A visual examination of the significant changes to the architectural form of the Firth House.

April 2023

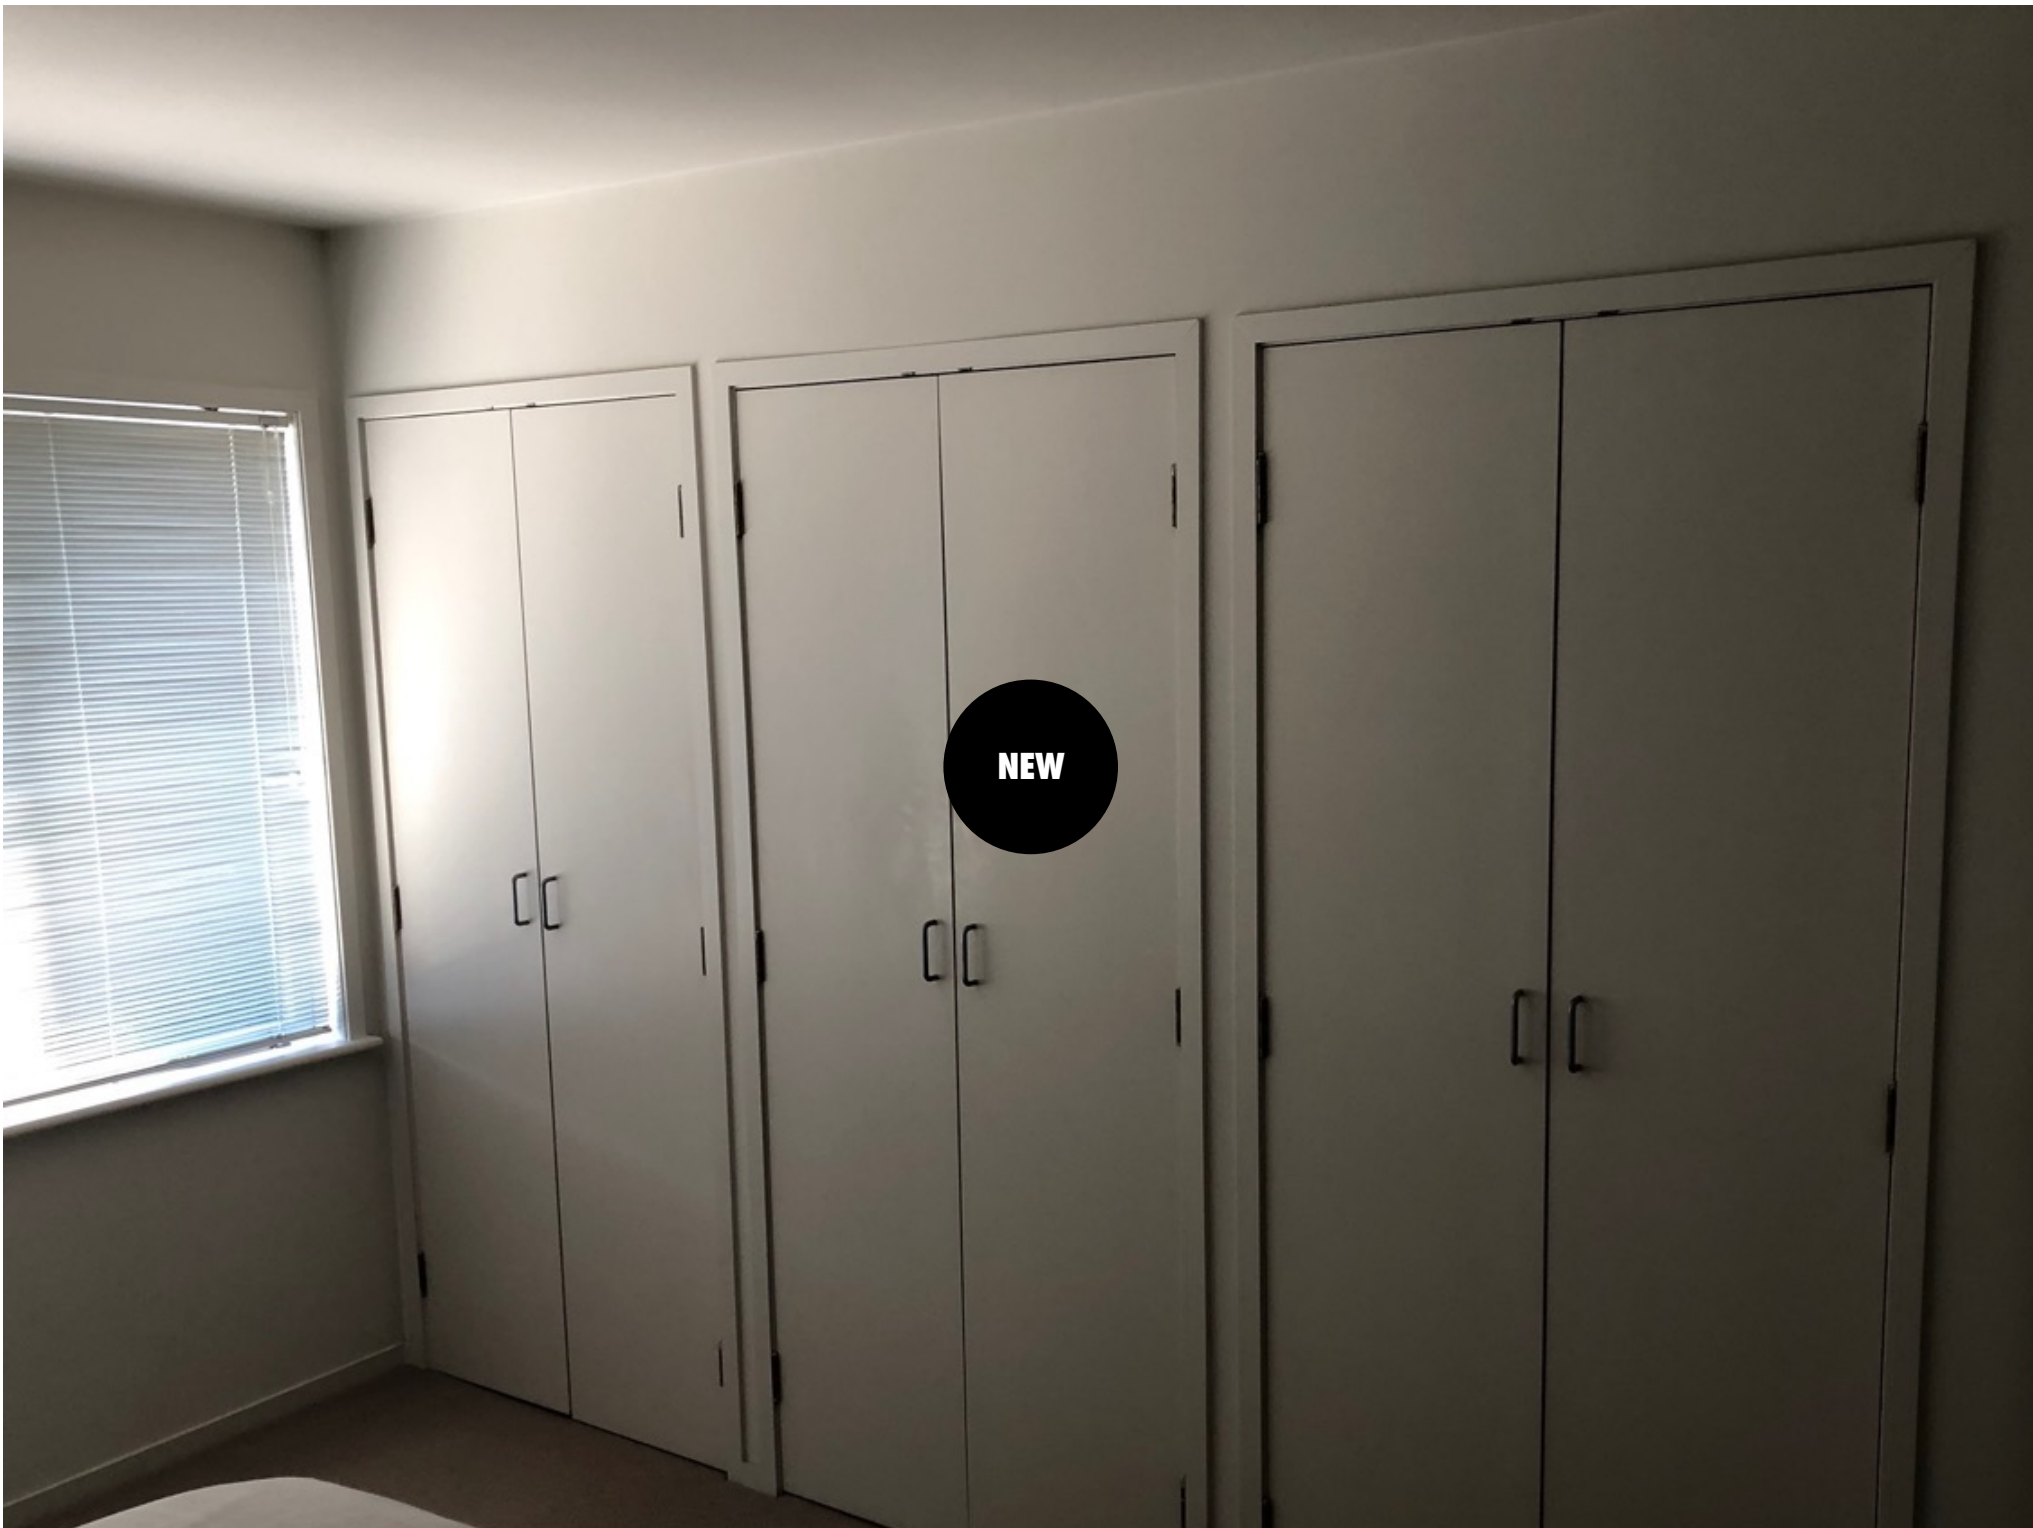
NEW: illustrates the architectural spaces, forms, elements and colour palette that are new and are not as originally designed and built by Firth.
